Access Compliance Report

Public Rights-of-Way

| Intersection ID: 11739 | Main Street: W_9TH_ST | Cross Street: N_CHURCH_ST | Location: | N |
| ADA ID: 247481459A51 | Ramp Type: PerpDiag | Initial Pass/Fail: Fail | Overall Compliance: No | Severity Score: 22.5 |

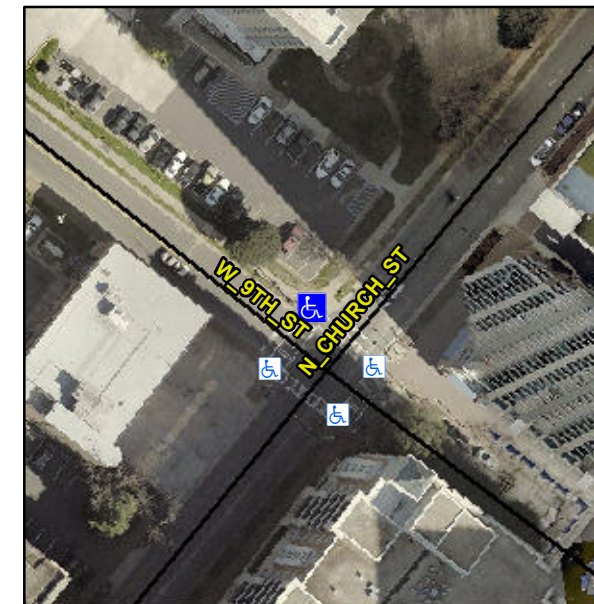
Not Found, R304.5.1, R304.2.2

| Compliance | Description | Data | Compliance | Description | Data |
|------------|-----------------------|-------|------------|-----------------------------|-------|
| N/A | Ramp Length (in) | 60.0 | No | Ramp Slope (%) | 9.9 |
| No | Ramp Width (in) | 36.0 | Yes | Ramp XSlope (%) | 3.9 |

Remove & Replace Curb Ramp With Two New Directional Ramps or Equivalent.
